EPA Comment C-14-2 Background conditions since CCA

Comment C-14-3 Post-CCA seismic events

Figure 1. Piper diagrams for samples collected from WQSP wells from 1995 through 2002.

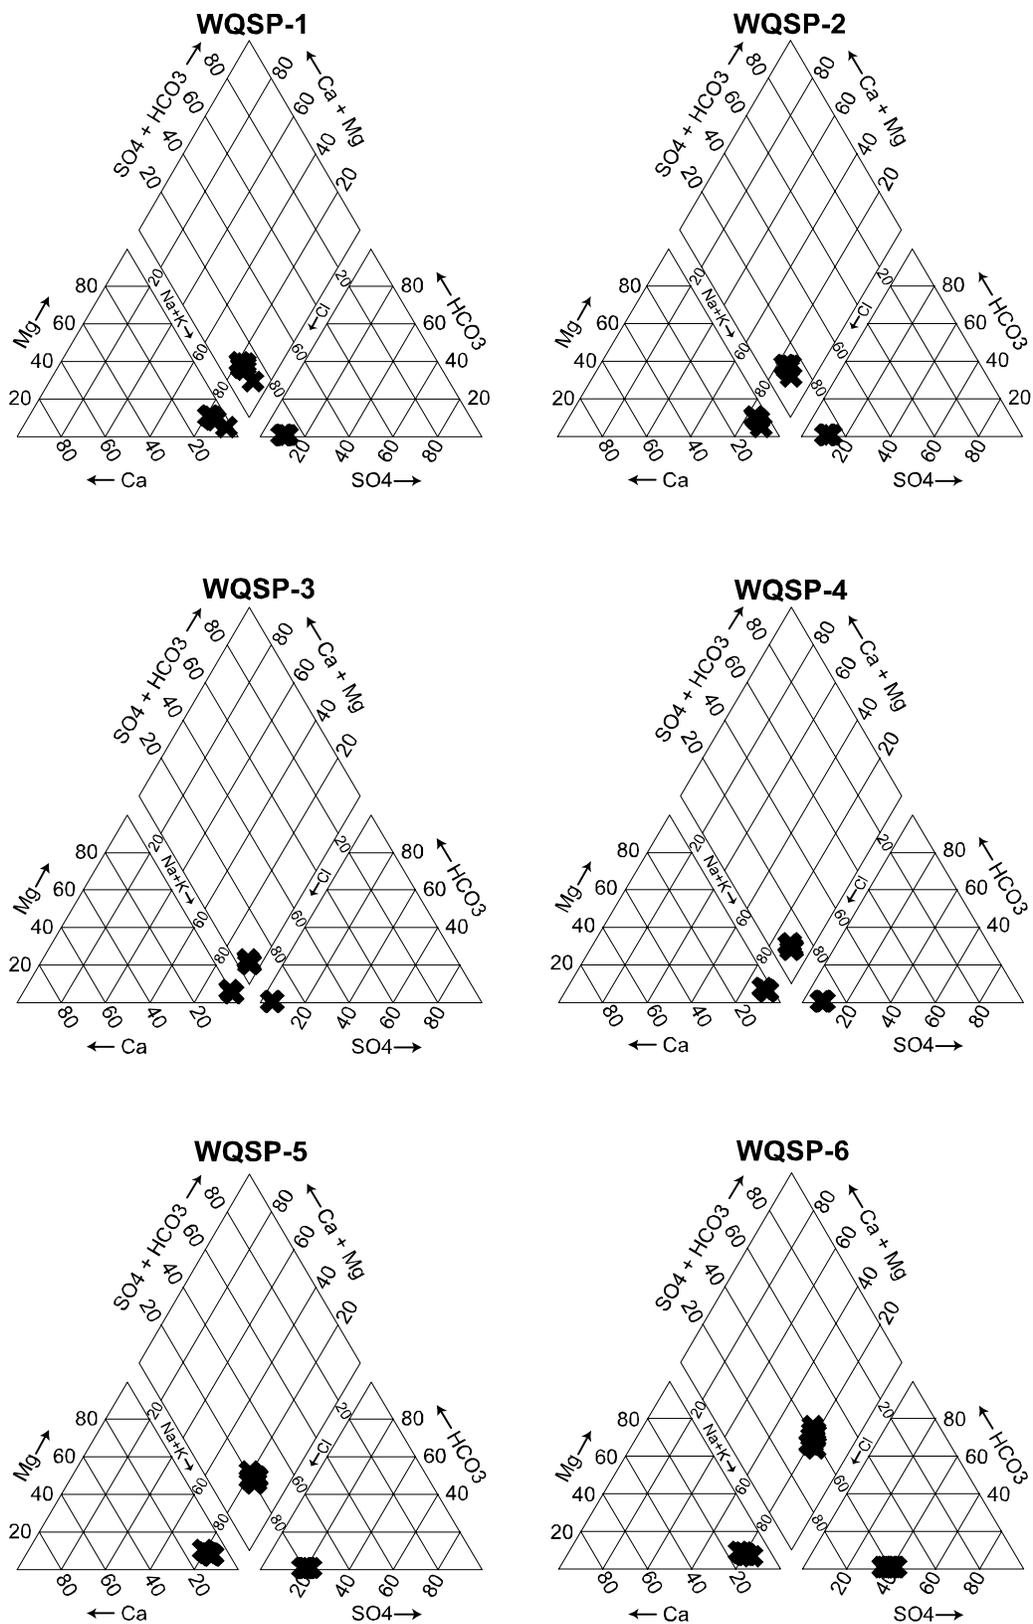
DOE has removed discussion of all “background” environmental conditions, but does not address how information obtained since the approval of the CCA may have affected these “background” conditions. For example, groundwater monitoring has occurred for several years, yet the discussion pertaining to Water Quality remains unchanged with respect to the hydrochemical facies.

The discussion pertaining to water quality has not changed since the CCA because monitoring has detected no changes in groundwater quality. Figure 1 shows Piper diagrams with the results of 15 rounds of sampling at the WQSP Culebra wells conducted between 1995 and 2002 (WRES 2003). The first 10 rounds (collected through May 2000) were used to establish baseline concentrations of the major ions (IT Corporation 2000). No changes to the baseline hydrochemical facies were observed over the five subsequent rounds of sampling. WRES (2003) presents time-trend plots for the major ions and other water-quality parameters for all 15 rounds of sampling, showing the absence of changes from the baseline values.

Figure 2-57. Seismic events with a magnitude greater than 3.0 within 150 miles of the WIPP site.

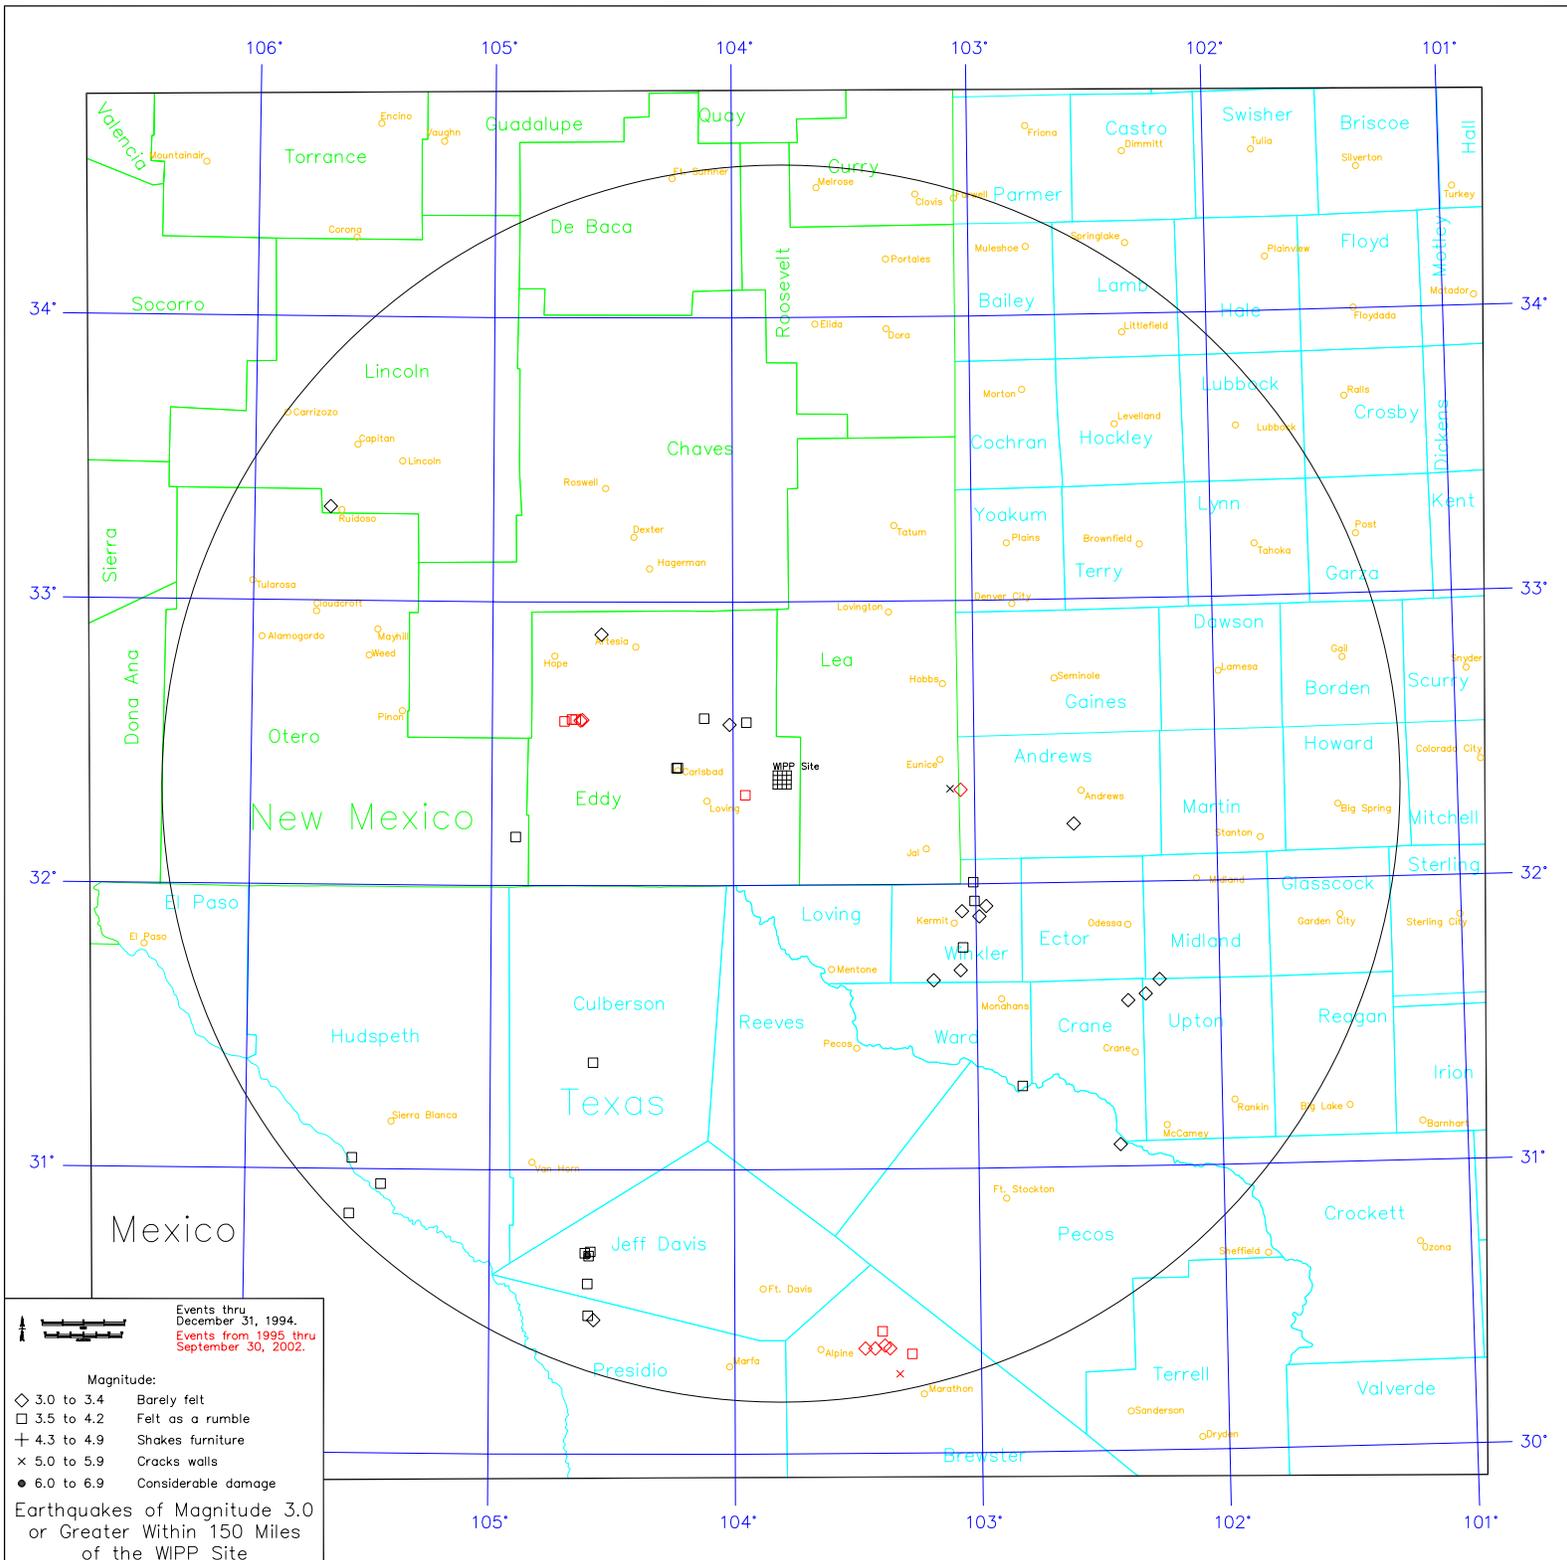
The CRA includes a discussion of seismicity in the WIPP vicinity, but does not discuss post-CCA seismic events. If no events occurred, the CRA should so state. Additionally, Figure 2-57 does not clearly present events that are “post CCA”, even though the title of the figure implies that it includes these events. DOE needs to identify the seismic events that have occurred since the CCA.

Figure 2-57 has been updated to show the seismic events with a magnitude greater than 3.0 within 150 miles of the WIPP Site. The seismic events in black occurred during the CCA time frame, while the events in red are from the CRA time frame. Also provided is a table that defines the location, the magnitude, the time, and the date of each event in Figure 2-57.
